# UNITED STATES PATENT AND TRADEMARK OFFICE

APPLICATION NO.	FILING DATE	FIRST NAMED INVENTOR	ATTORNEY DOCKET NO.	CONFIRMATION NO.
10/614,532	07/07/2003	David H. McFadden	54330/322597	9062

## Office Action Summary

**DETAILED ACTION**

**Segment of Fig. 8 of Smith**

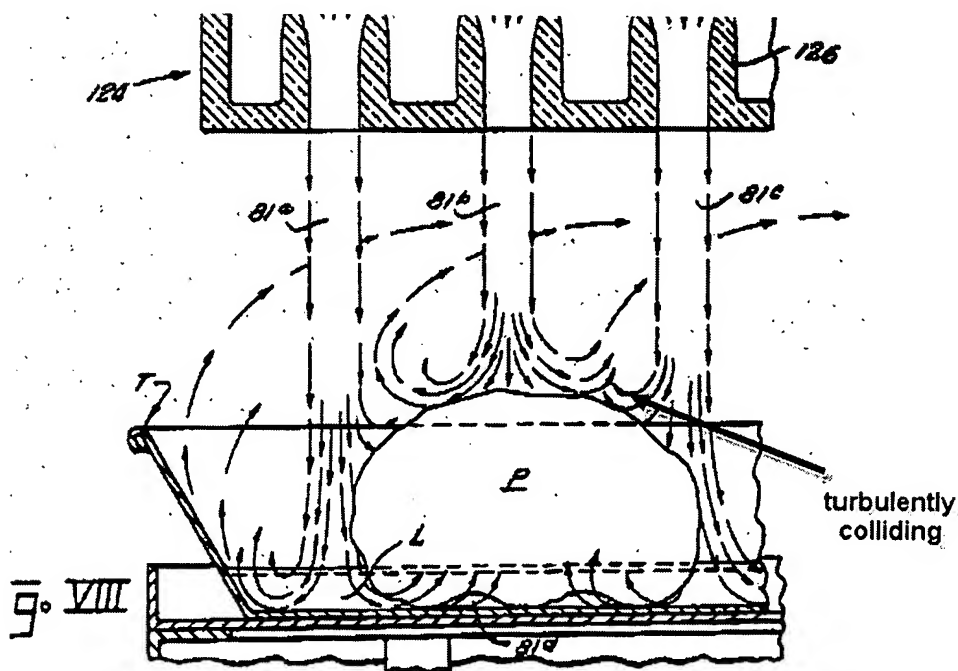
a first means (any one of 80, Figs. 2 and 3 or 124, Fig. 8) for directing gas within the cooking chamber and a second means (any other adjacent nozzle/opening 80, Figs. 2 and 3 or 124, Fig. 8). Each of openings (80 or 124) is disposed above the food product for directing gas above the food product. Gas from the openings is provided in the form of jets (81). As shown particular in Fig. 8, a first gas jet (81b) and a second gas jet (81c) are provided to strike a food product (P) and are considered to collide turbulently in close proximity to a surface of the food product to desirable enable "very rapid heat transfer and very rapid water vapor removal from the surface of the product" (see col. 10, lines 45-51). The following is a segment of Fig. 8 of Smith to further illustrate what the examiner considered to be "turbulently colliding" gas flows:

(examiner has added arrow and text)

Further, the examiner notes that Smith expressly notes that jets (81) when striking a solid surface will be transformed into a “turbulent mushroom shaped pressure area” (see col. 11, lines 6-11).

While this discussion is in the context of the jets striking the bottom of the food product, the examiner considers that a person of ordinary skill in the art would recognize that the “turbulent mushroom shaped pressure area” would also result on the top of the food product (as shown for instance in Fig. 8 of Smith).
